City of Alexandria, Virginia

MEMORANDUM

TO: CHAIR AND MEMBERS OF THE
BOARD OF ARCHITECTURAL REVIEW

SUBJECT: 3rd CONCEPT REVIEW OF 101 DUKE STREET
BAR CASE # 2020-00612

1 UNION STREET ELEVATION.
1/8" = 1'-0"

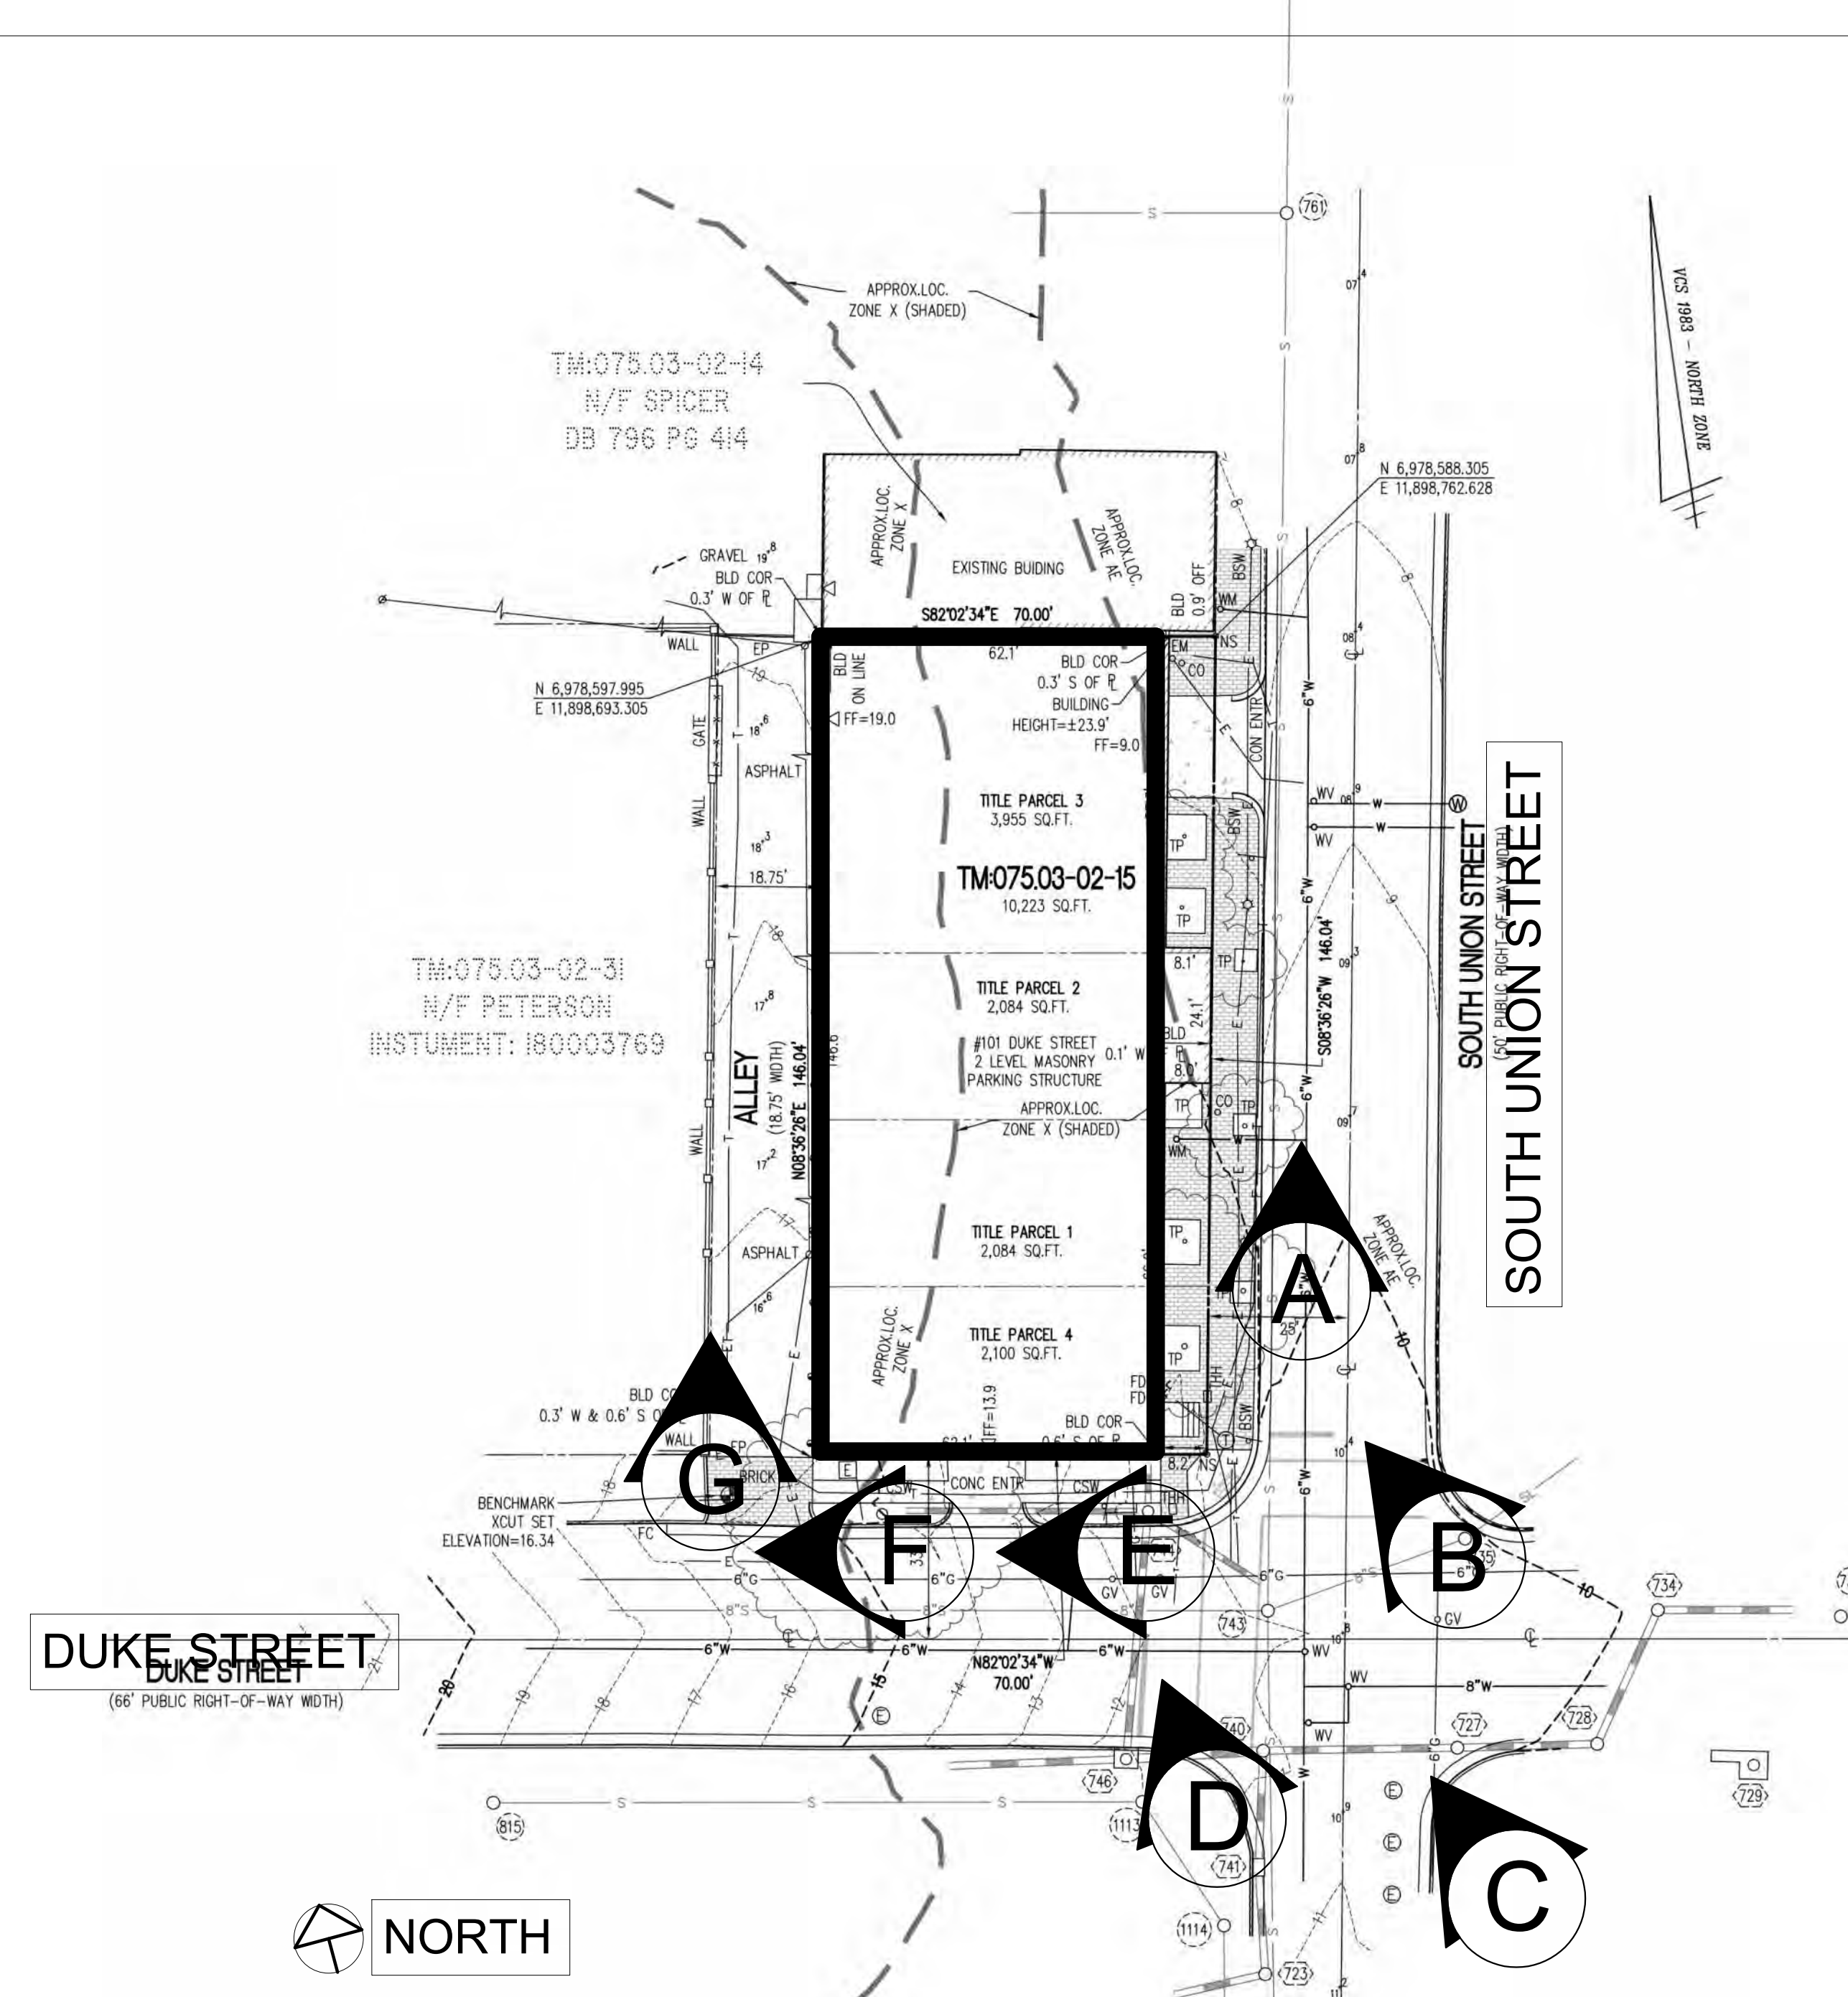
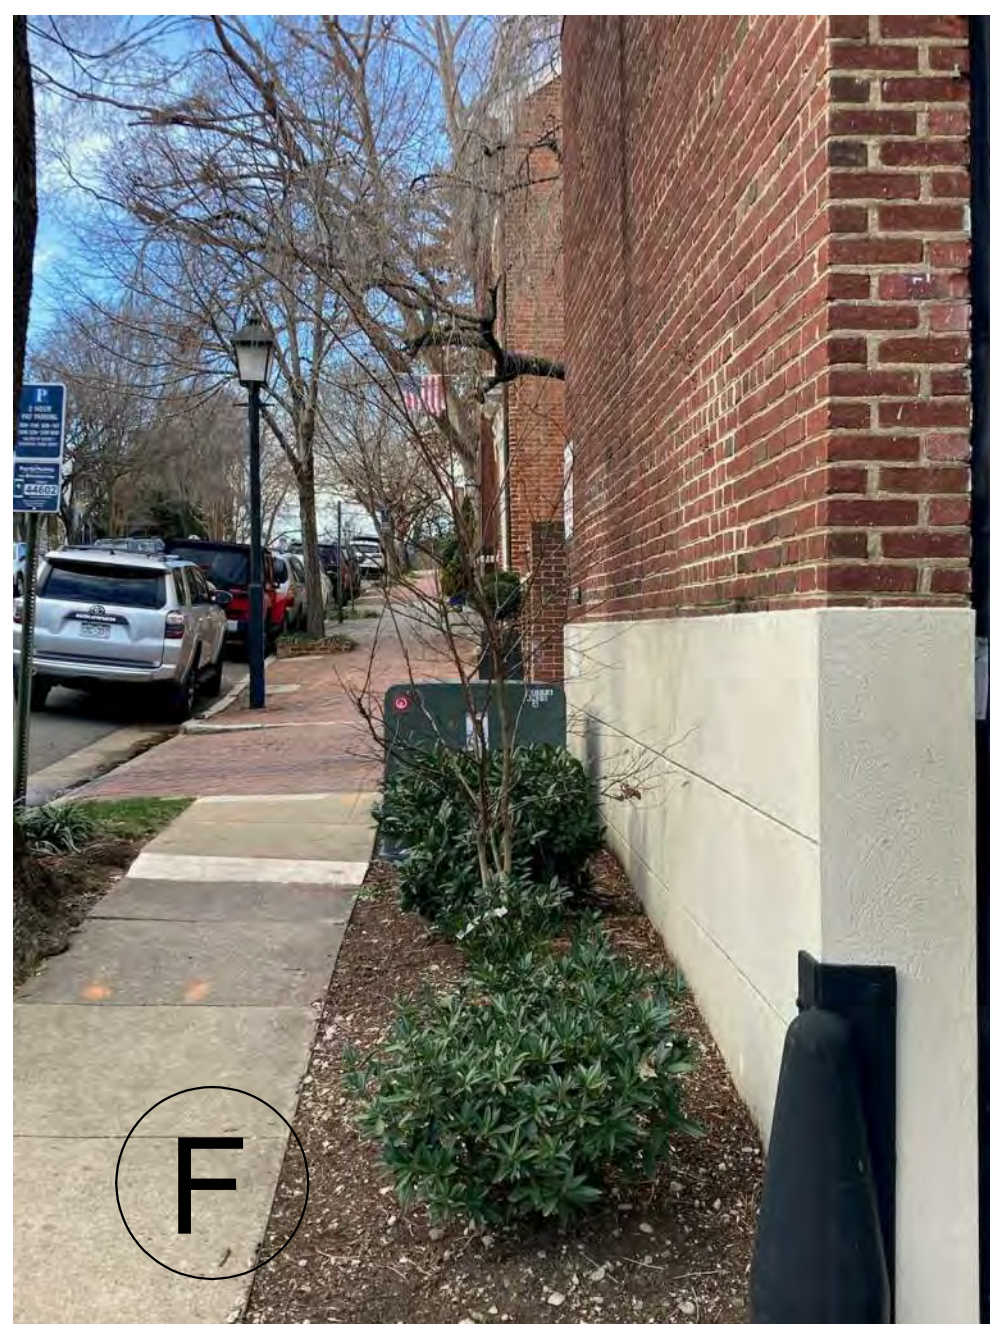
An effective way to reduce the perceived scale of a building is through the use of highly articulated masonry detailing. It is understood that the design is at an early stage where this level of articulation has not yet been considered. However, as the project continues to evolve, the applicant should explore ways to include detailed brick articulation to the various elements. Using layers of brick detailing around wall openings can help organize the elevations and give the impression of a more accessible scale.

The north building in particular uses brick for the window heads and sills, and projecting bands (Figure 6). It is unclear from the renderings what the proposed material will be at the pier caps and parapet cap at the top of the building, but they appear to match the brick in color. The articulation of these masonry elements will be an important way in which the building will relate to the historic fabric. Care should be taken as the detailing evolves to look to historic precedent for inspiration.

The design for the entry stoops on Union Street has evolved over the course of the design process on this project. The applicant has worked on the grade issue identified in the first BAR hearing to lower them as much as possible and has proposed a variety of different designs. The current proposal includes different designs for each of the buildings (Figure 7). The north building uses brick piers to support a brick landing with metal stairs and a metal screen below the landing. The south building has a similar landing but with brick stairs in lieu of the metal stairs. Staff is supportive of the different approaches for each building to further differentiate the buildings and make for a more pleasant pedestrian experience on Union Street.

At this concept design phase, the details for how these stairs will be built remains unclear. The use of a metal screen below the landing does recall some raised entry stairs located throughout the district but those are largely located in conjunction with English basements. As the design progresses into the Certificate of Appropriateness stage, the detailing of how this area works will be critical to a successful streetscape. The applicant should explore options for how the screen engages with the piers and what is behind the screens. If it is to be a shadow box configuration then the depth will be important in order to be believable. If it is completely open under the landing, then that will help with the transparency, but provisions will need to be made for maintenance of this area. Staff encourages the applicant to explore options for this design and look to decorative metalwork in the historic district for inspiration.

As noted above, the applicant is carrying the design for the Union Street elevation around the south east corner of the building to approximately the third point. At this point the elevation changes to a simpler design with brick window heads and sills and recessed brick panels. The corner element helps to draw attention to this as an important entry point to the historic district from the south. The more simple portion of the elevation is aligned with the design for the rear of the building and is compatible with the traditional notion of there being a hierarchy between the front and other elevations. Similar to previous versions of the design, this elevation includes recessed masonry panels that are similar in size and configuration to the punched windows (Figure 8). These panels are meant to provide a level of articulation to the exterior wall and manage the use of the interior space.

Staff supports the idea of turning the corner with the design motif from the Union Street elevation to the Duke Street elevation as a reinforcement of the corner and a clearly identifiable modern building design. The composition of the remainder of the Duke Street elevation should be further studied to balance the recessed masonry panels with the punched openings. The adjacent houses on Duke Street provide some typical window spacing and ratios between solid and void that can be studied to provide direction for a compatible design. This type of study is appropriate for the Certificate of Appropriateness phase along with a greater level of detail for the recessed masonry panels.

The alley elevation has been simplified from previous designs to reinforce the hierarchy of elevations found throughout the historic district. The punched windows are similar to those found on the Union Street elevation but have more simple surrounds and brick detailing. The recessed panels above the second-floor windows help to reduce the unbroken area of masonry made necessary by the raised brick parapet at the third floor (Figure 9).

The elevation is broken into thirds by the inclusion of surface mounted downspouts that extend from the upper roof. The division of the elevation into thirds helps to break down the massing, but the use of surface mounted downspouts to achieve this relies on an auxiliary building element rather than an integrated architectural expression. The applicant should explore ways in which to integrate the downspouts into the architecture of the wall to create an intentional architectural response to this practical need. One option could be to create vertical notches in the exterior wall with the downspouts recessed into these notches. This would clearly divide the elevation into thirds while collecting and organizing the downspouts.
